Preliminary Consultation
MONTGOMERY COUNTY HISTORIC PRESERVATION COMMISSION
STAFF REPORT

Address:	11650 Snowden Pkwy., Germantown Formerly 22022 Ridge Rd.	Meeting Date:	1/24/2024
Resource:	Master Plan Site #13/19 <i>Howes Farm</i>	Report Date:	1/17/2024
Applicant:	NECC	Public Notice:	1/10/2024
Review:	Preliminary Consultation	Staff:	Dan Bruechert
Proposal:	New Podiums and Accessory Structure Construction

Figure 2: June 2021 concept site plan with statues labeled as 'B' and 'C.'

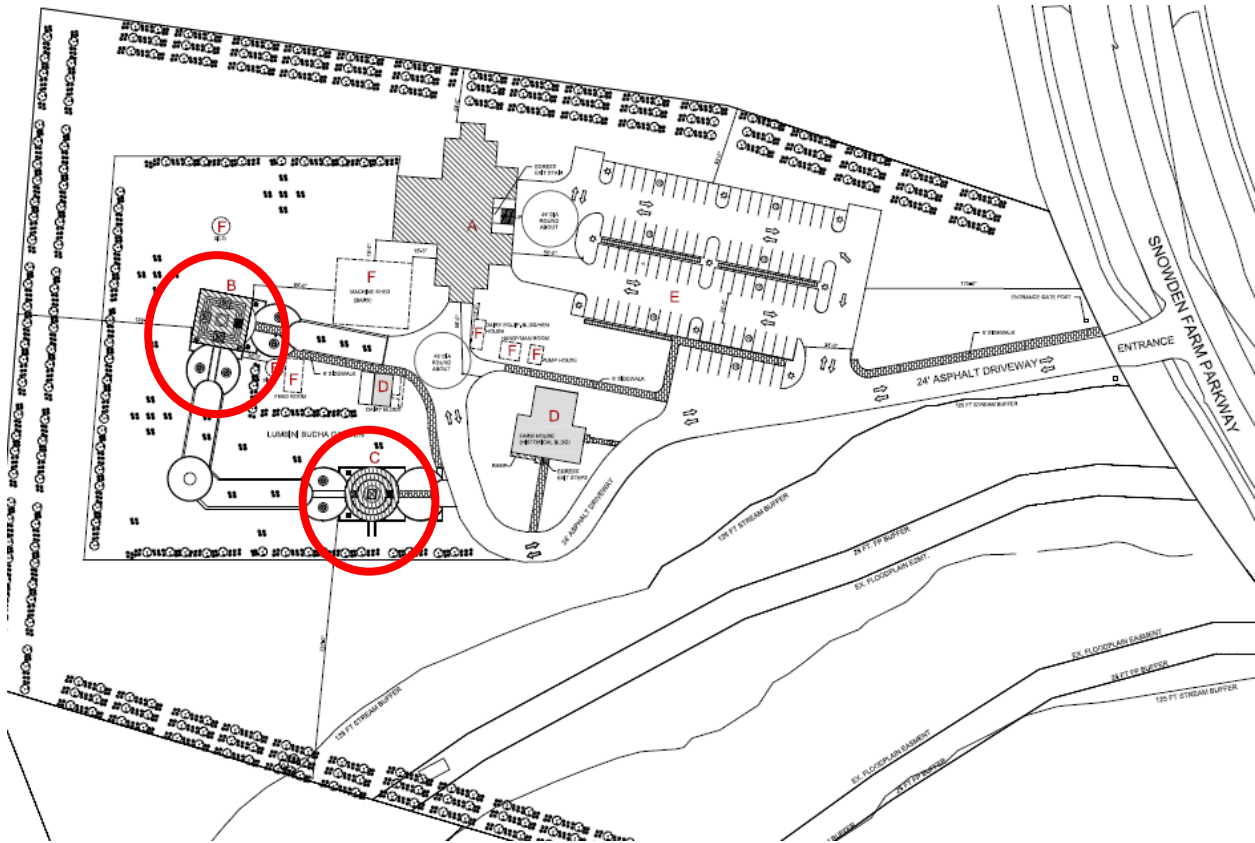
Staff finds the proposed podiums are generally consistent with the HPC's support from the June 2021 Preliminary Consultation (see *Figs. 2 and 3*, above). Staff finds the proposed placement of podium 'B' is slightly further to the south than originally proposed and, because it is not directly behind the historic house, it will be more visible from the right-of-way. Staff finds the placement of the proposed podiums to be far enough from the historic structures that it will not negatively impact their character.

Figure 3: Current proposal showing the proposed podiums as 'A' and 'B.'

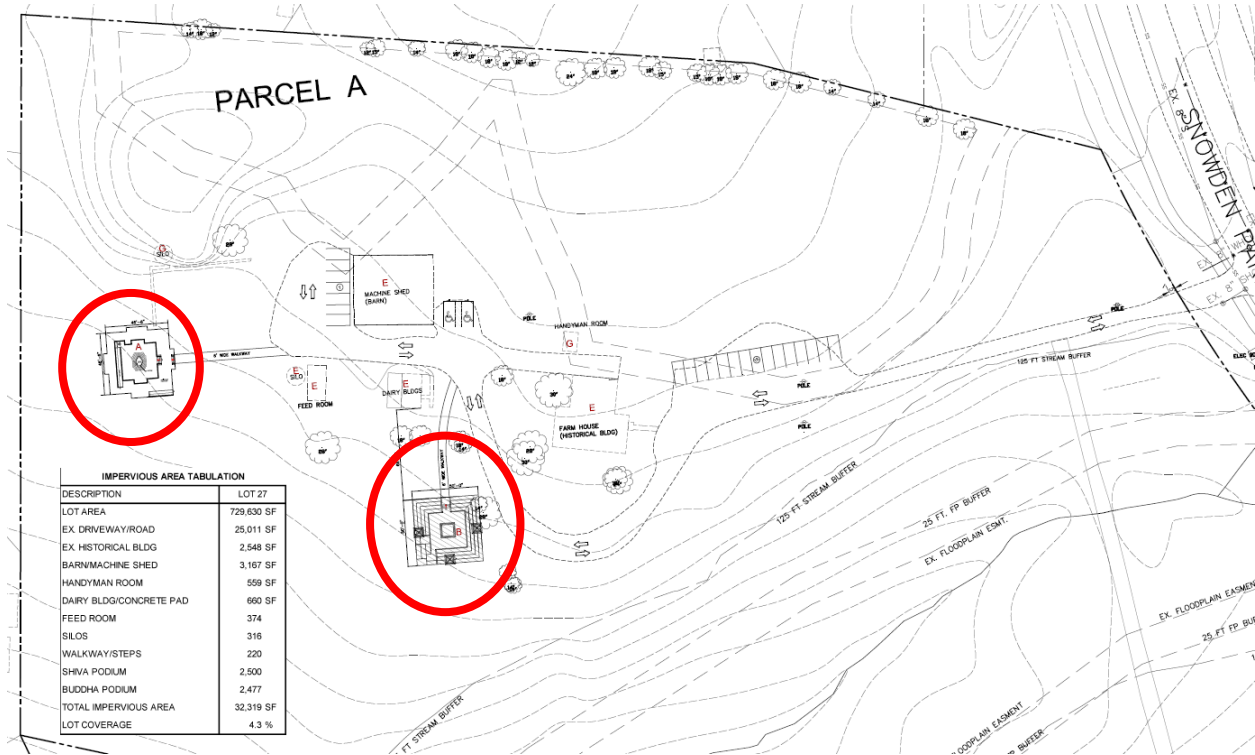
Staff additionally finds the materials (concrete and brick) are compatible for landscape features at the subject property. Staff requests feedback from the HPC on the:

- Proposed podium/statue locations;
- The proposed materials; and,
- Any other recommended revisions.

The proposed site plan (*Fig. 3*) also shows new hardscaping on the site including additional parking, relocating a portion of the driveway, and walkways to the proposed podiums. The application packet identifies 6' (six foot) wide walkways but does not include a material specification.

Staff finds the 6' (six foot) width of the proposed walkway is potentially out of character with the site; however, Staff additionally recognizes the desire to make the site accessible, which means a solid, impervious material is likely preferred. Staff recommends either asphalt or a tinted concrete, but requests input from the HPC for a preferred material.

Finally, the site plan shows an expanded driveway with additional parking. These elements are rendered with a dashed line, however, Staff requests feedback from the HPC on the appropriateness of the expanded parking – particularly regarding the parking in front of the historic house. While the existing driveway on site is gravel, no material was identified for the new driveway on site. Staff request feedback from the HPC on both the location of the expanded drive and parking and recommended material.
